Re: Comments on Draft TEIR for Proposed Buena Vista Rancheria Casino Project

The County submits this letter to provide comments on the document entitled Draft Tribal Environmental Impact Report ("DTEIR" or "Draft TEIR") dated May 11, 2005.

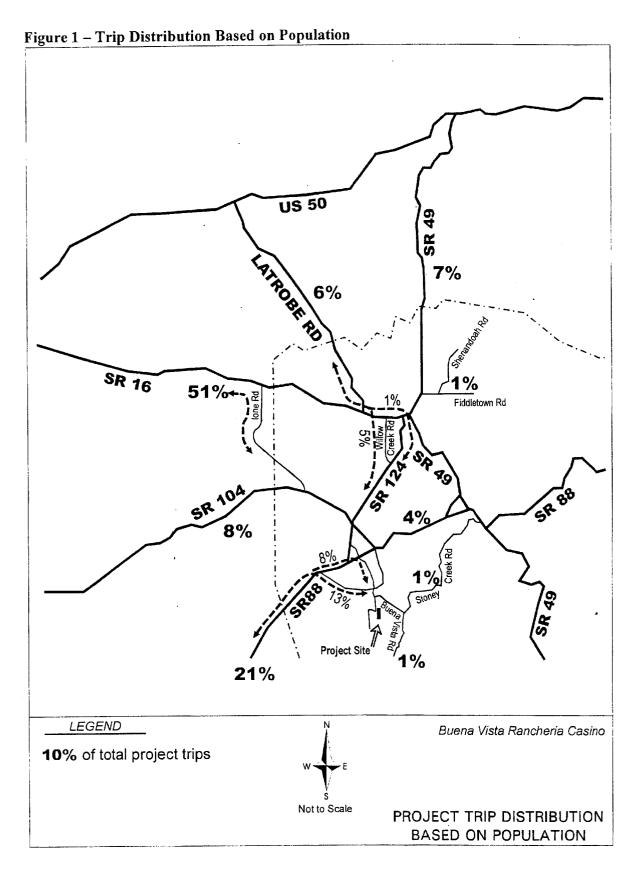
The Draft TEIR assumes that the directional distribution of the project's traffic will be in accordance with a confidential market analysis. If the project's traffic distribution is estimated using the population distribution within a 70-mile radius of the project a significantly different distribution pattern emerges. For example, if within this distribution area, about 60% of the project traffic is assumed to be oriented to the area within 35 miles of the site, about 30% of the project traffic is assumed to be oriented to the area between 35 and 70 miles from the site, and about 10% of the project traffic is assumed to be oriented to the area beyond 70 miles from the site the pattern shown in Figure 1 results.
